BUTTE REGIONAL TRANSIT OPERATIONS CENTER

Tenant Improvement

ADDENDUM NO. 1

1/4/2016

ROOF PLAN

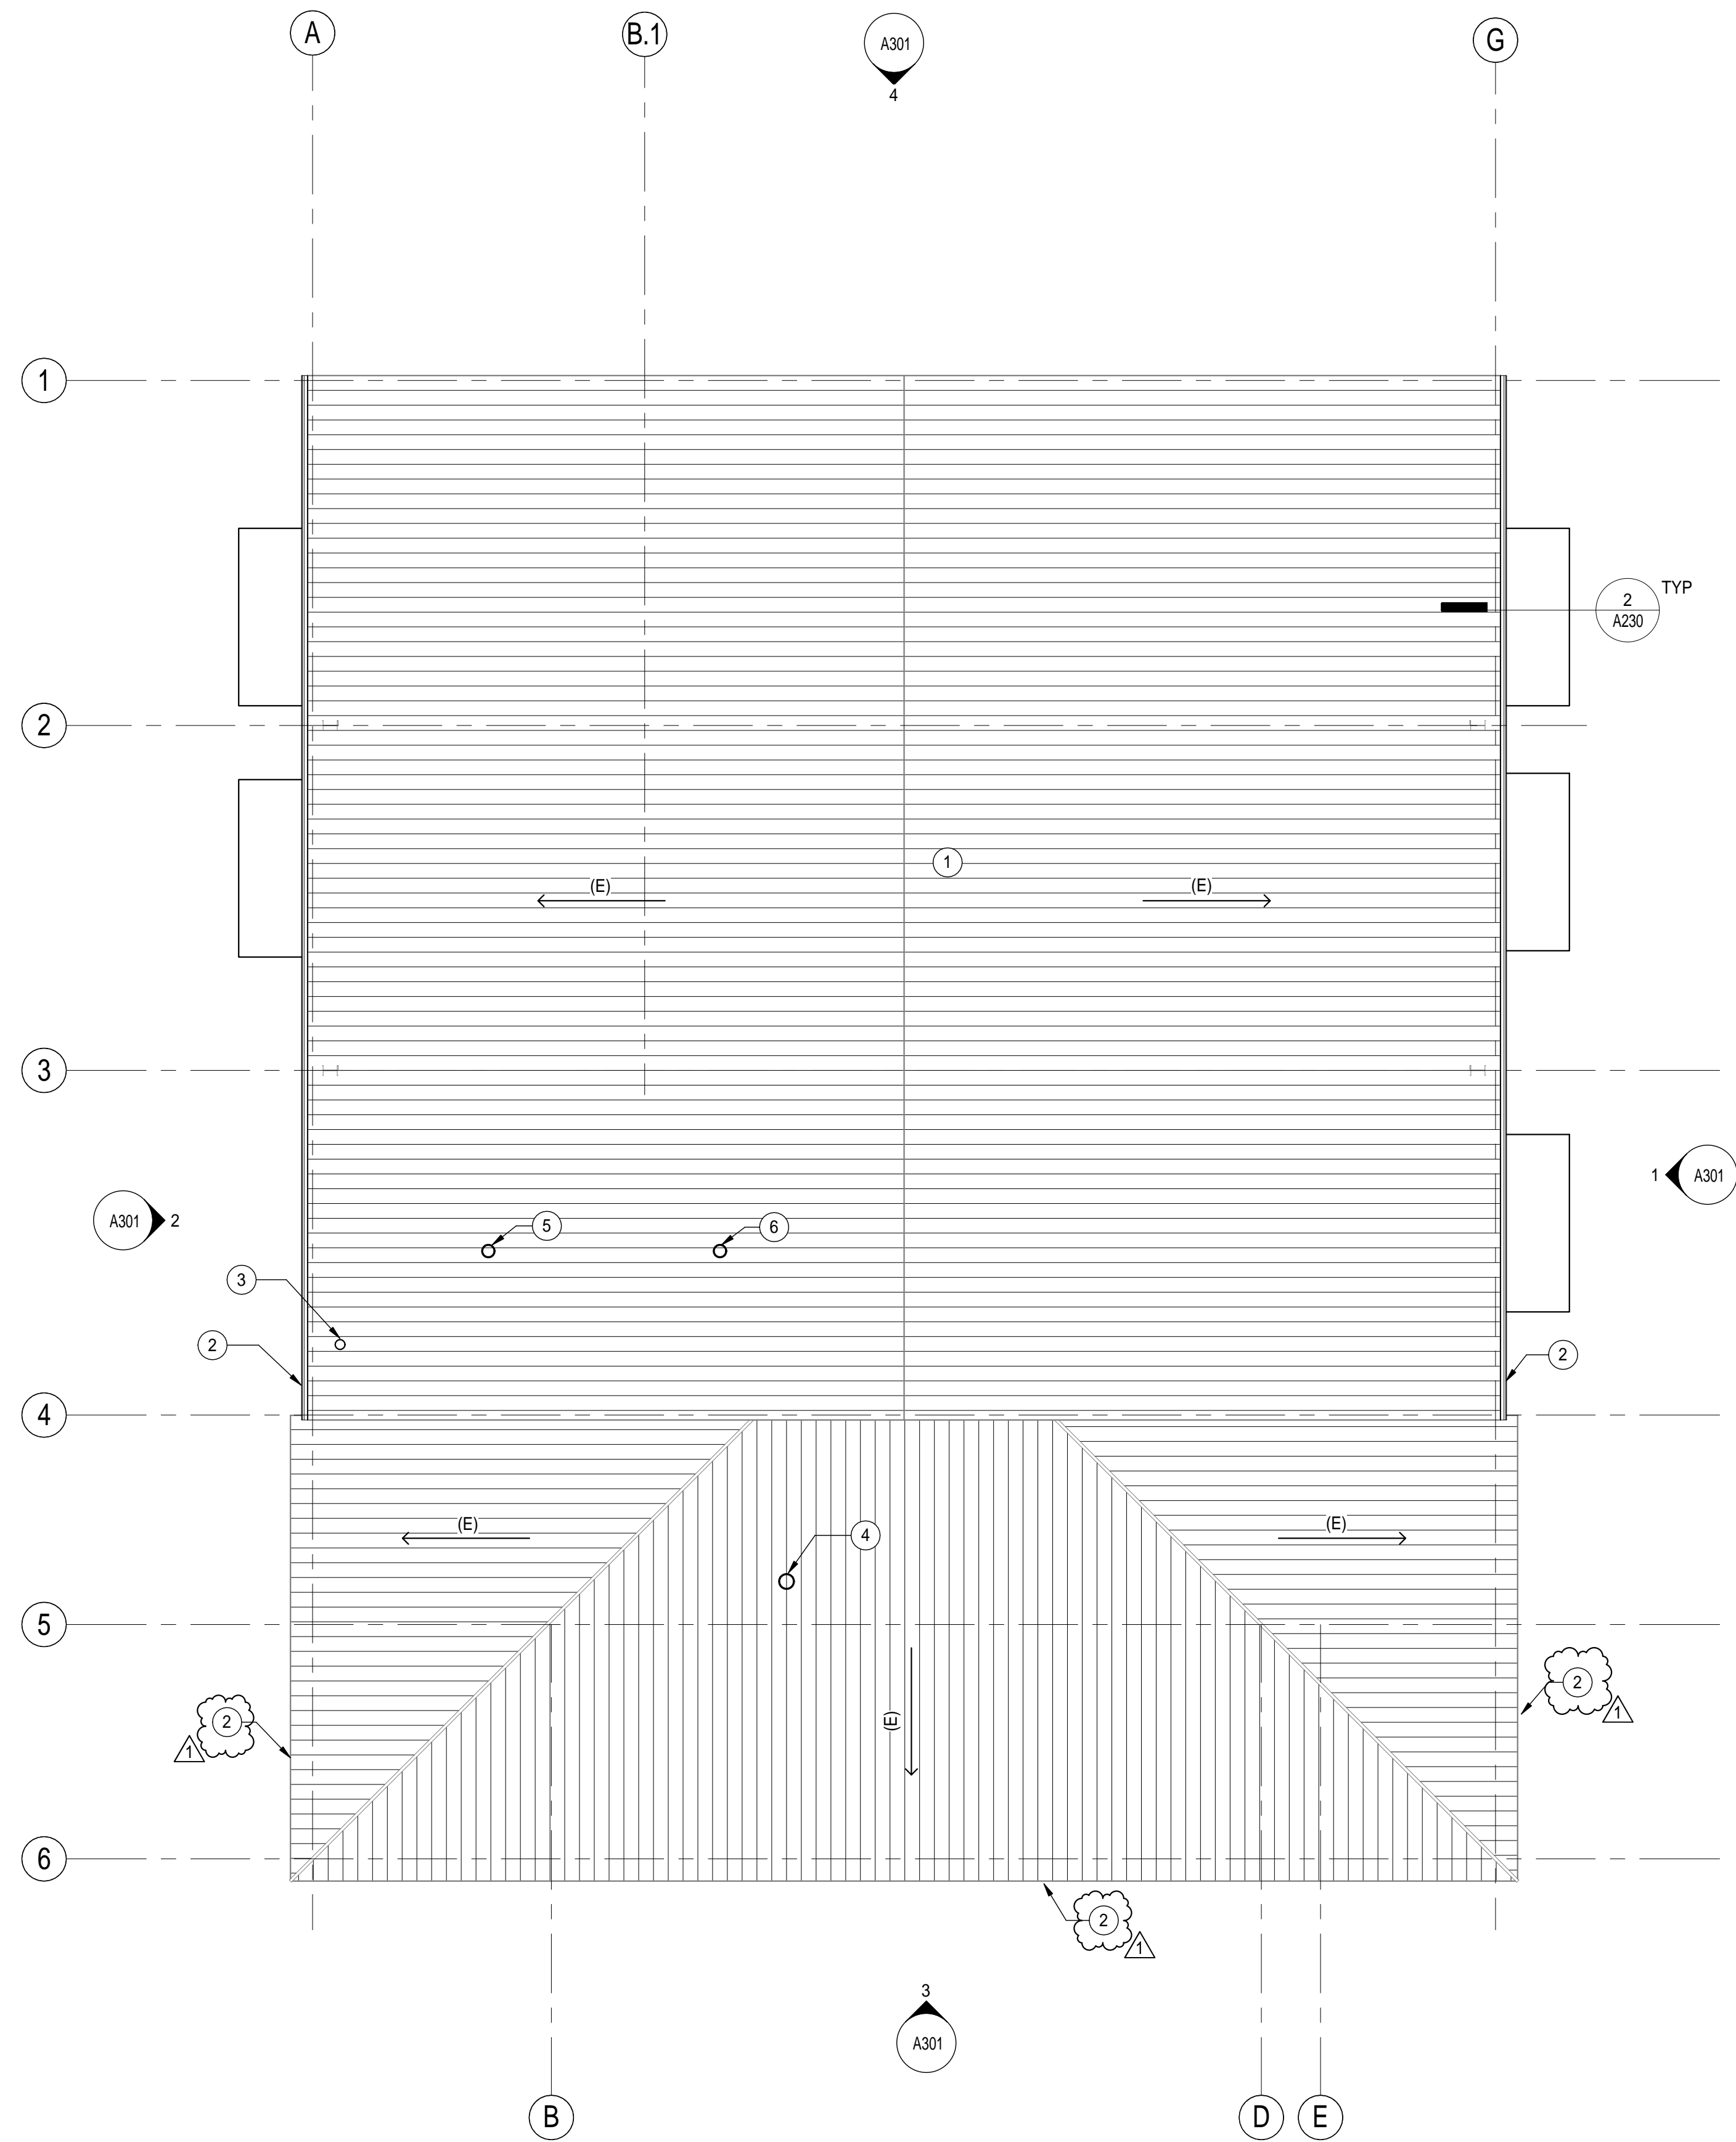
- 1.5 REVISION TO SHEET A230 - ROOF PLAN
 - a. Keynote 2 applies to low roof also
- 1.6 REVISION TO SHEET A301 - EXTERIOR ELEVATIONS
 - a. Keynote 5 revised to identify EP1 finish

SHEET TITLE:
EXTERIOR ELEVATIONS

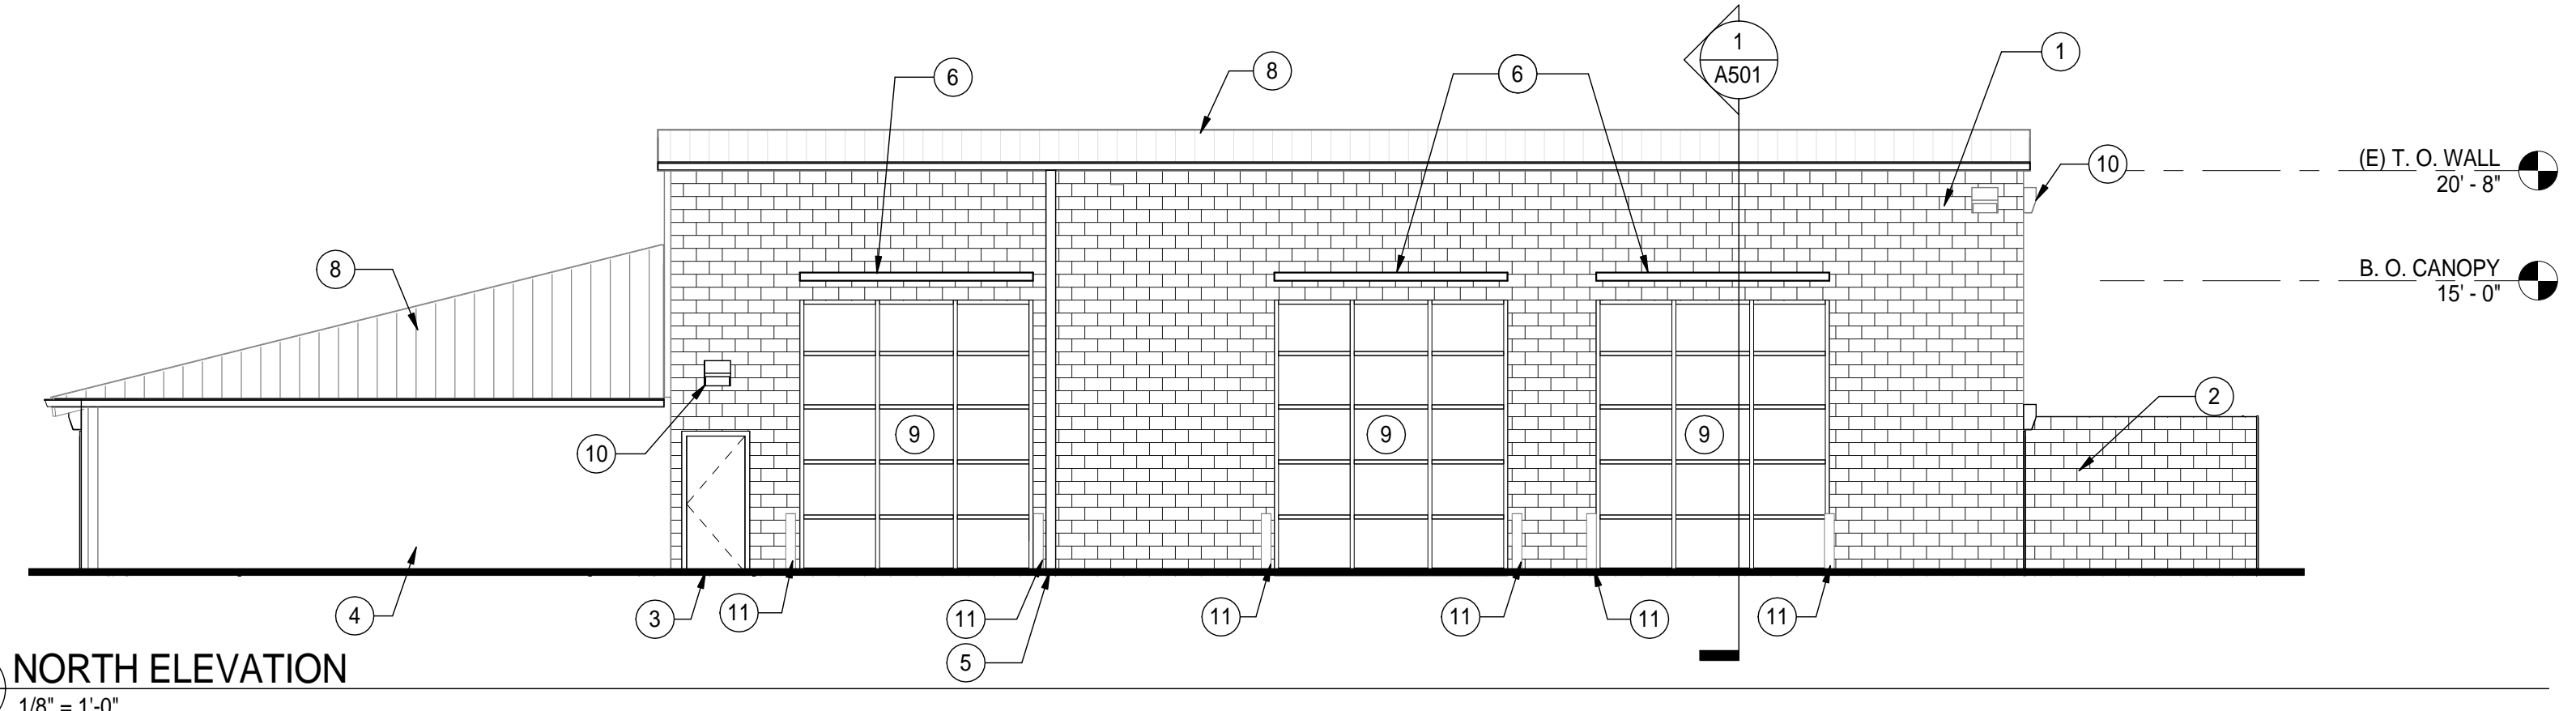
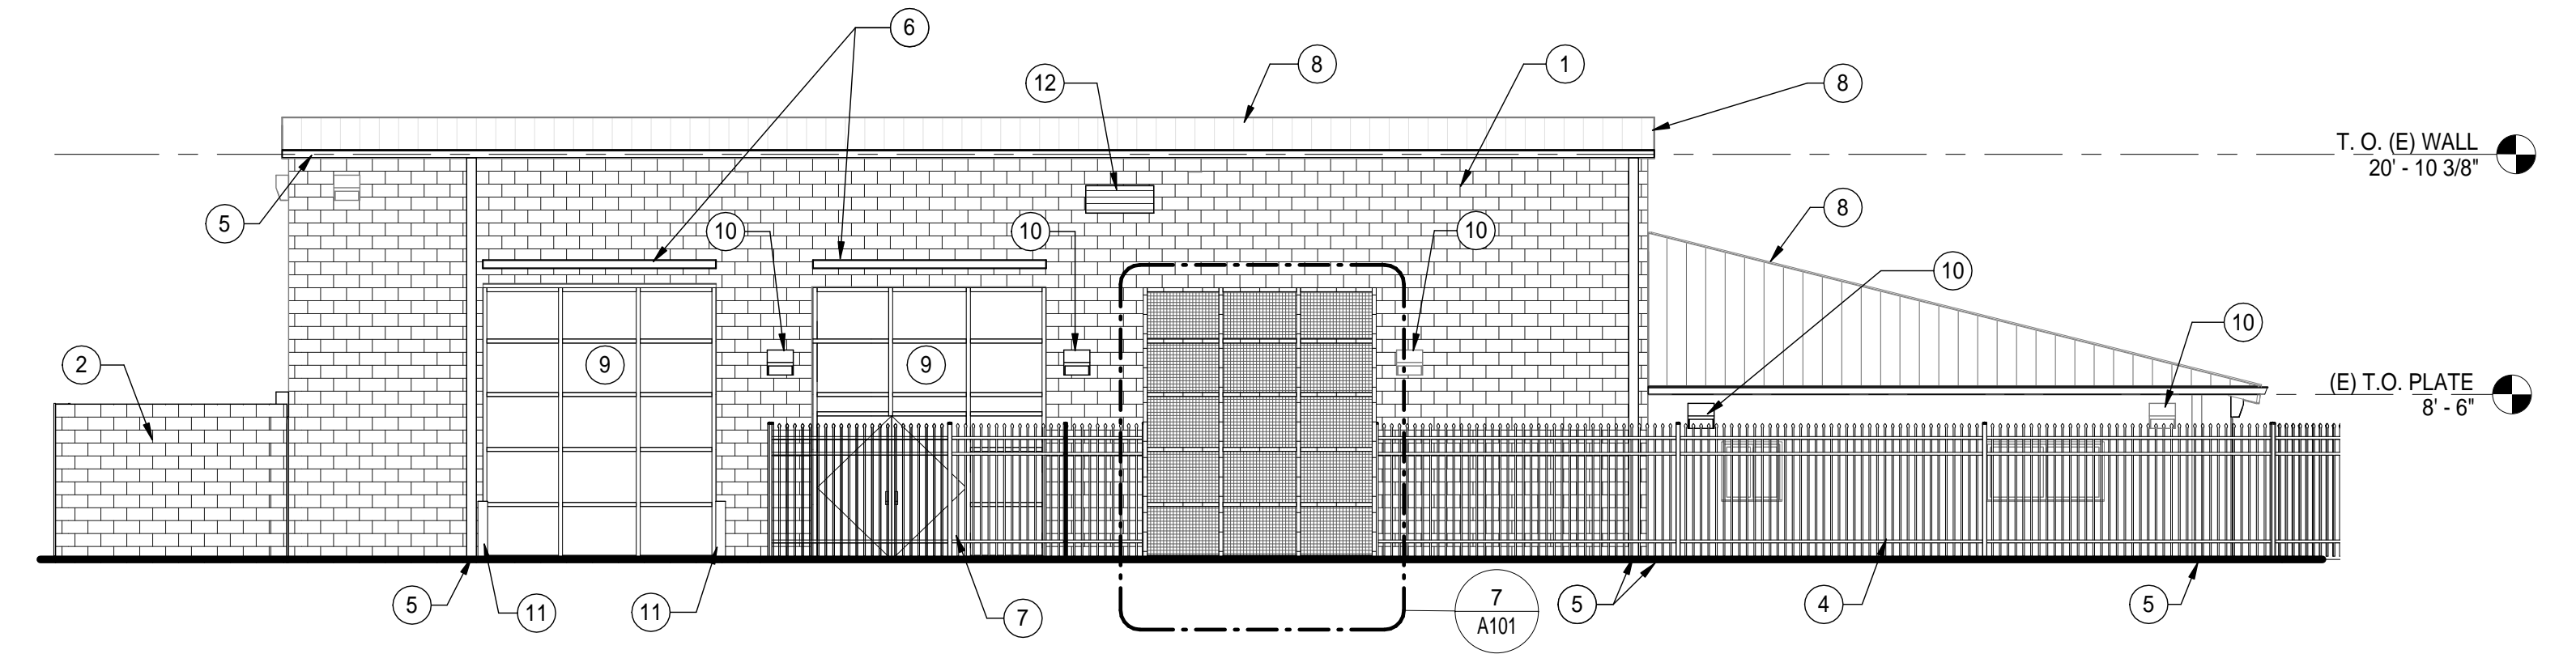
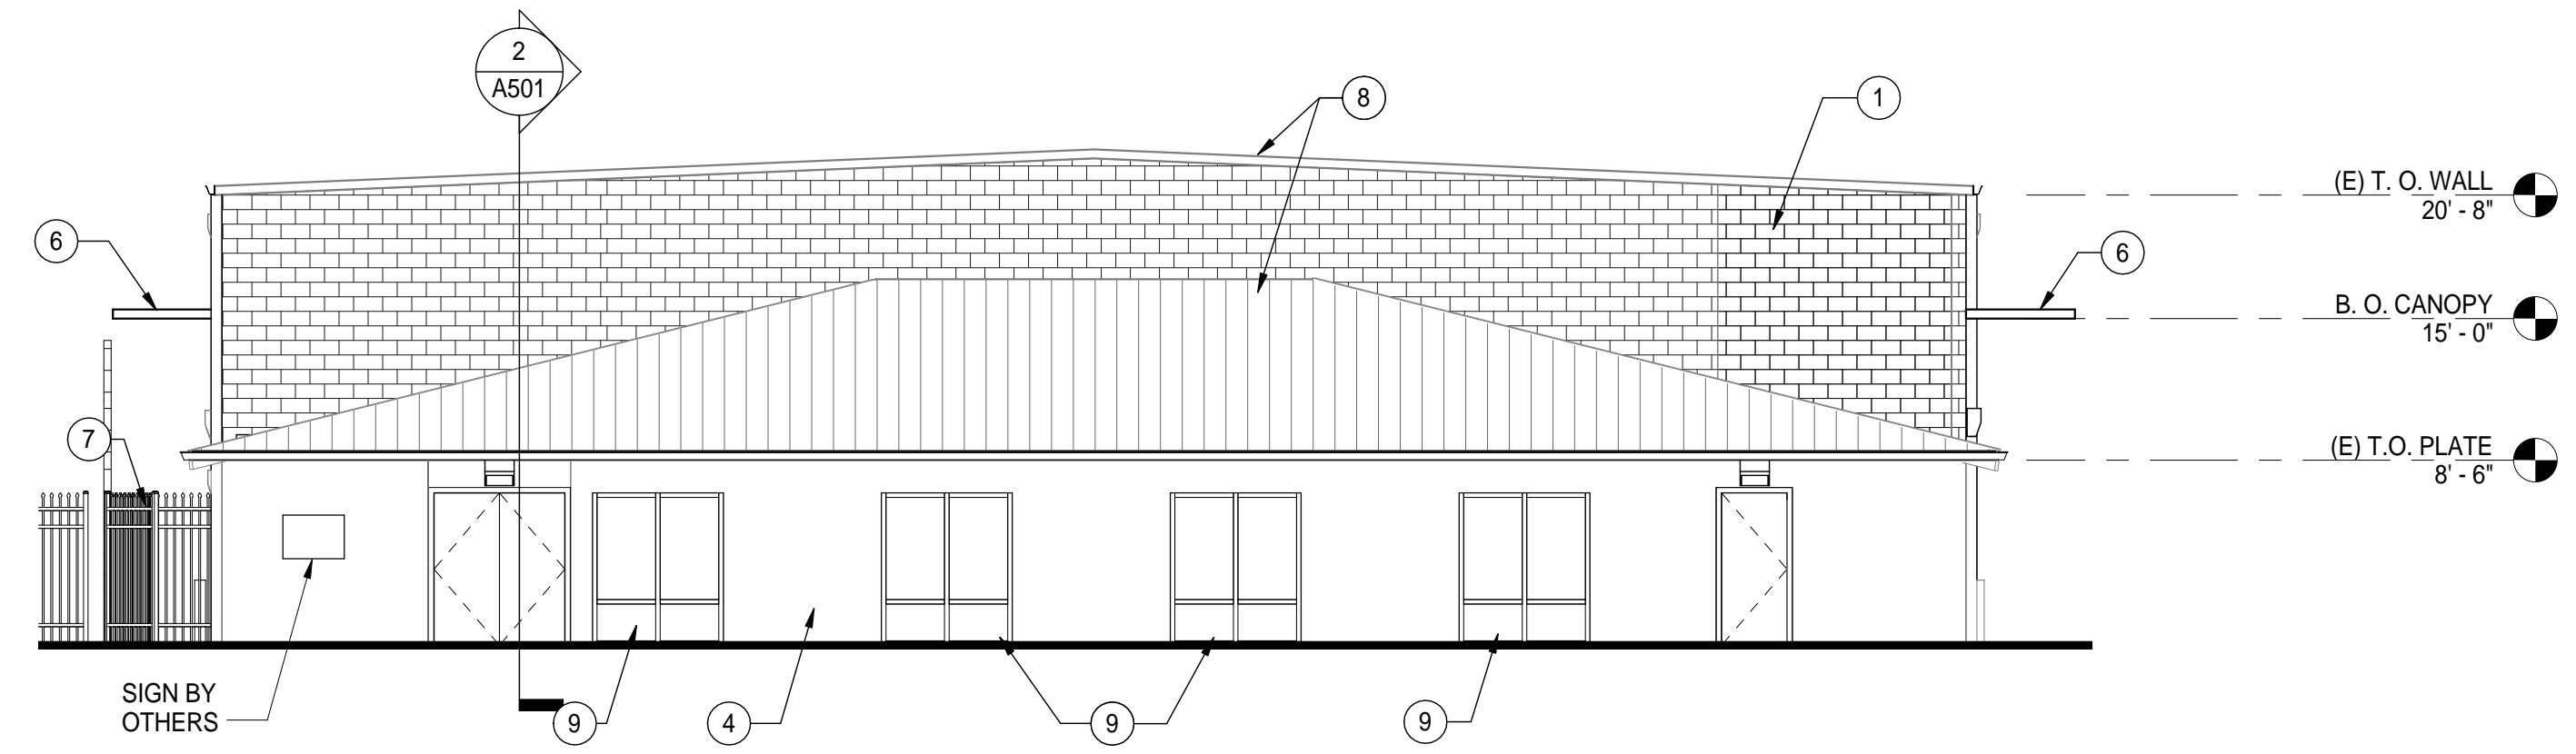
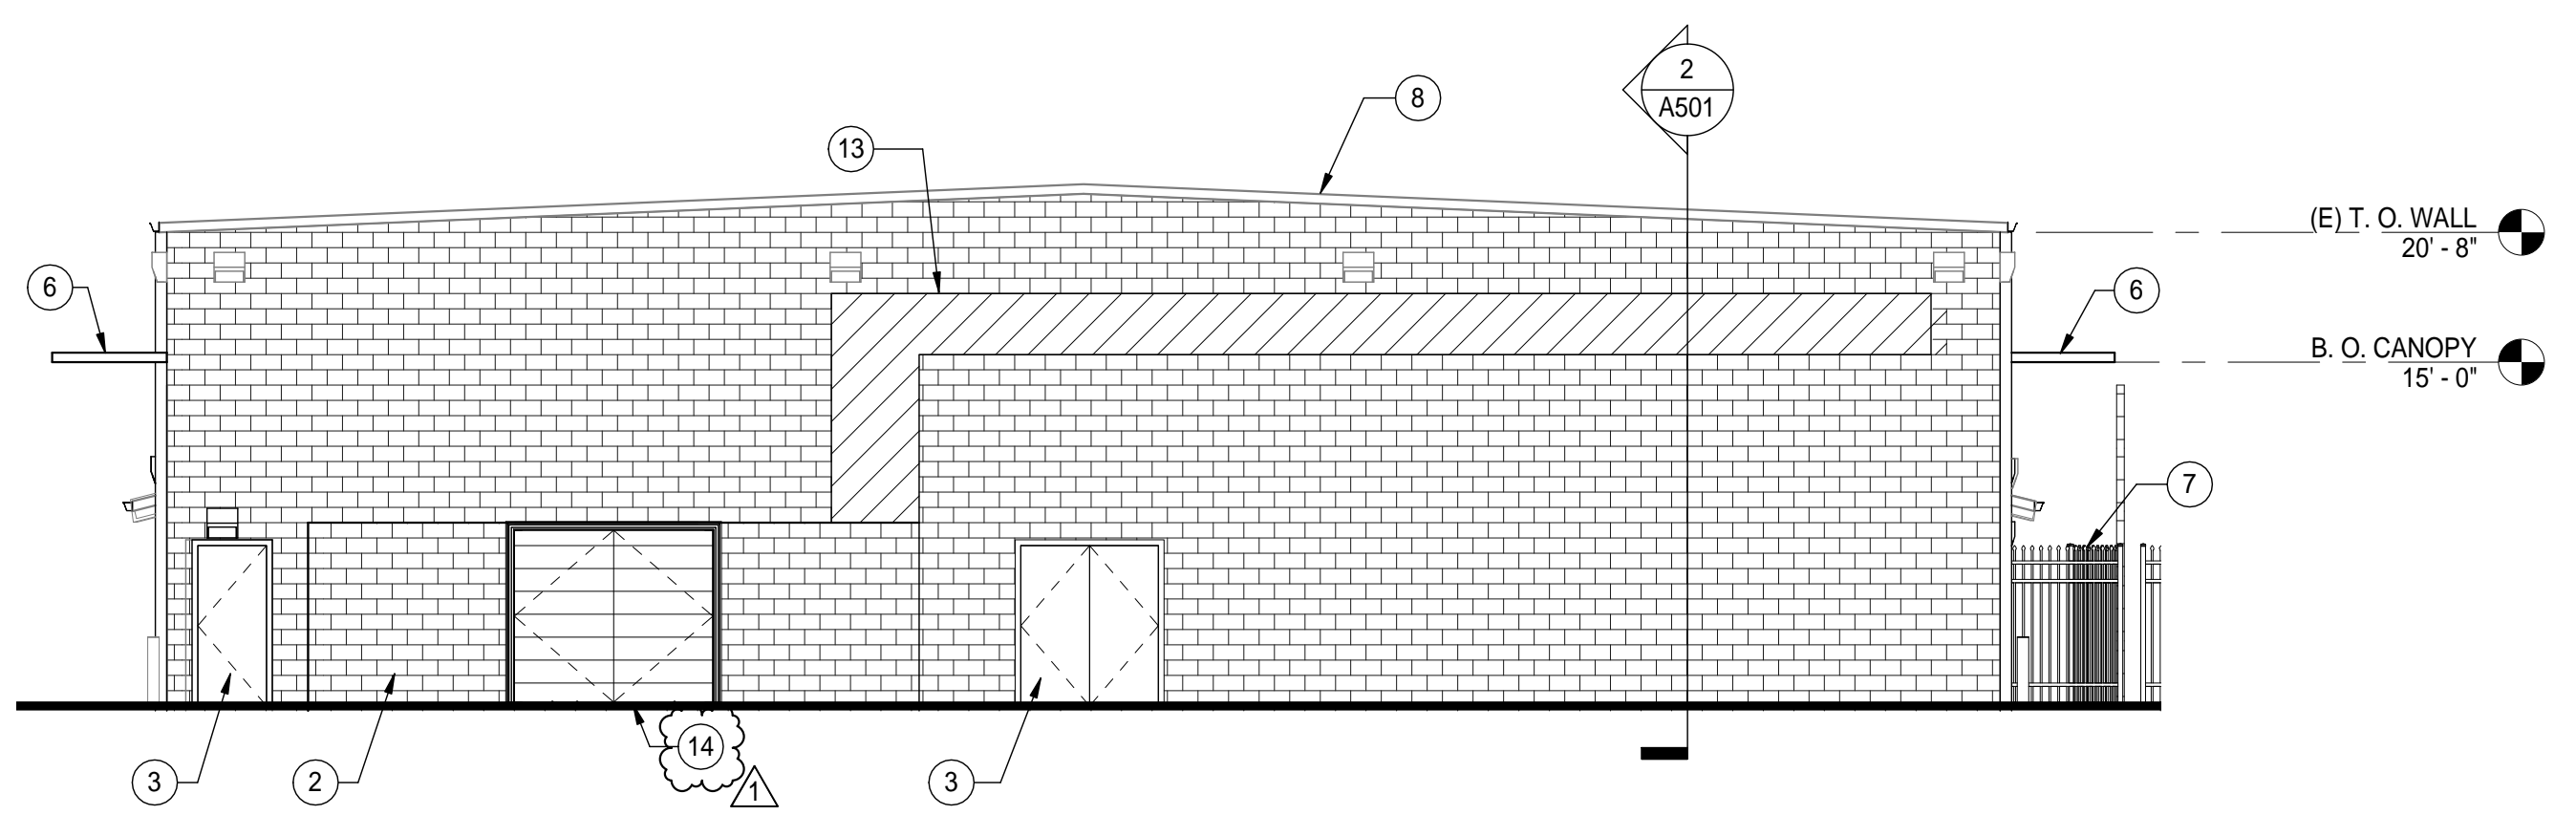
- b. Keynote 14 added
 - c. Detail 4 - West Elevation - Keynote 14 shown at louvered gate
 - d. Finish schedule revised
- 1.7 REVISION TO DRAWING A601 - SIGNAGE PLAN & ROOM FINISH SCHEDULE
